Shearwater Petrel 2/Perdix/Perdix AI/NERD 2/ Peregrine Firmware Release Notes

VERSION 95 2022-12-21

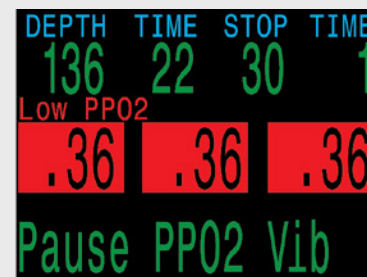
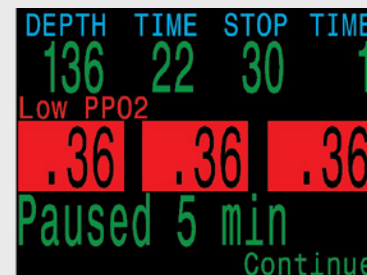
Continuous vibrating alarms for externally monitored (CCR) low and high PPO2 have been added.

Due to the critical importance of PPO2 levels in a closed-circuit rebreather, externally monitored PPO2 alarms will continue to vibrate every 10 seconds, even after the message has been acknowledged, as long as the alarm condition remains.

When a Low or High external PPO2 alarm exists, the vibrating alarm will continue even after the Warning message has been cleared.

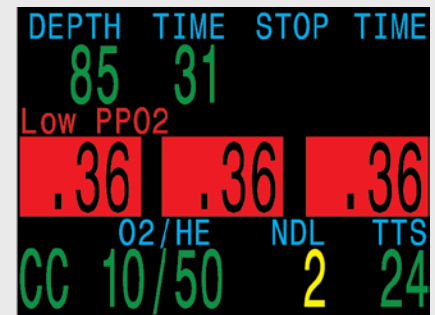
A “Pause PPO2 Vib.” Menu option will be available while a PPO2 vibrating alarm condition is active. This will pause PPO2 vibrating alarms for five (5) minutes. During this time other warning conditions will still cause vibrations.

While such vibrations are active, a menu option will be available to Pause PPO2 Vibrations

This will pause vibrations for 5 minutes

A MINI display be chosen as the NDL Display setting

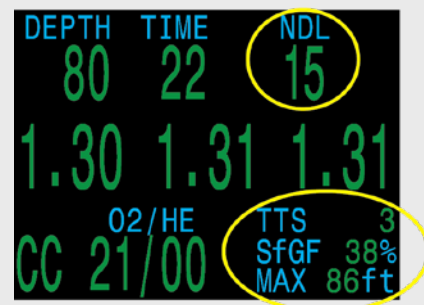
The “NDL Display” setting can be set to “Mini”. The Mini display can be configured to show 2 custom values, in addition to TTS which is fixed. The main display is slightly changed, with NDL moving up to the top right where DECO STOP is normally shown. NDL will show here until deco stops are needed, at which time it will change automatically to show deco stops.

This option will move NDL up to the DECO STOP area. Once deco stops are needed they will replace the NDL.

Surface GF is the gradient factor if you were to instantly ascend to the surface

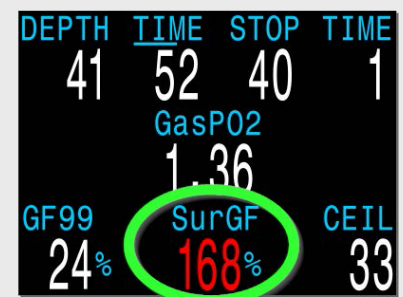
Surface GF display added. This shows the gradient factor if you were to surface immediately. This is different from GF99, which shows your gradient factor at the current depth. Is available:

Log Rate can be set to 2, 5, or 10 seconds

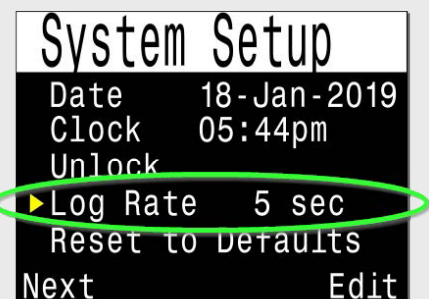
Log sampling rate can be set to 2, 5, or 10 seconds (previously always 10 seconds). Note that log downloads may take longer with faster sampling rates as more data is being recorded. Also, less logs can be stored until they are overwritten. For example, about 1000 hours are stored at a 10 second rate, but only 200 hours at a 2 second rate.

The “Clear Counter” counts up once deco is clear

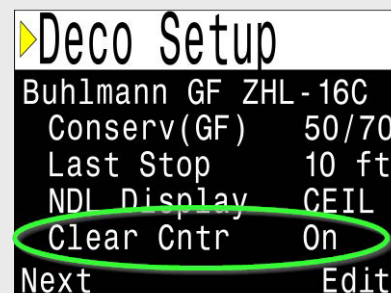
A “Deco Clear” up-counter option has been added.

When deco clears this counter begins counting up from 0. It is useful for timing additional padding after the mandatory decompression stops. If the dive did not need deco, then begins upon entering the safety stop zone (i.e. shallower than 20ft / 6m).

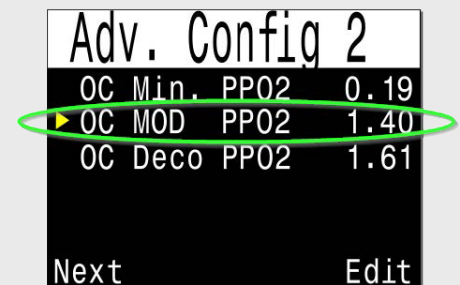
Previously, there was an “OC Max PPO2” setting which only defined when the “High PPO2” message occurred, regardless of dive phase (e.g. bottom depth or at deco stop). This confused many users who, quite reasonably, assumed it was the “bottom depth” limit and set it to 1.40. This would result in warnings during deco when the PPO2 was pushed to the 1.60 range.

The “OC Max PPO2” has now been removed and replaced with a “OC MOD PPO2” setting. The MOD setting only applies to the bottom depth phase. The dive computer automatically switches to using the “OC Deco PPO2” limit when within 2 stops of the next deco stop. The “OC Deco PPO2” limit also sets where predictive deco gas switches occur. Also, if the current gas has greater than or equal to 80% oxygen fraction, then the deco limit is used, as the gas is assumed to be a deco gas.

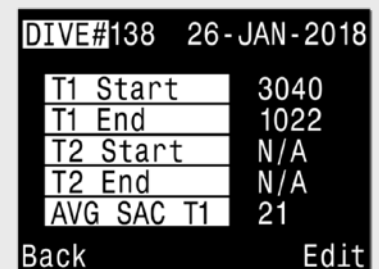
The in-computer dive log now displays start and end tank pressures and average SAC.

The mark heading command now requires less button presses

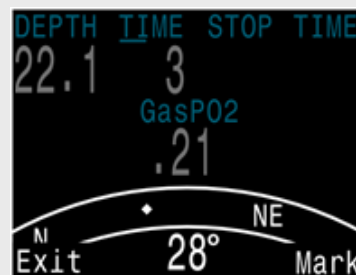
Compass mark heading menu moved to reduce button presses. Also, the compass can now be viewed while marking. Operation: when viewing compass a left button press brings up an "Exit/Mark" menu. Right press marks compass, Left press exits to main screen. Previously had to navigate to regular menus to mark the compass.

The offset between current and marked heading is now shown (in this example 16°)

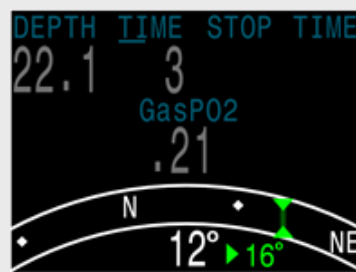
When a heading is marked, the display now shows the offset angle between the current heading and the marked heading. This is useful for navigating patterns. For example, a box pattern requires turns at 90° intervals, while a triangle pattern requires turns at 120° intervals.
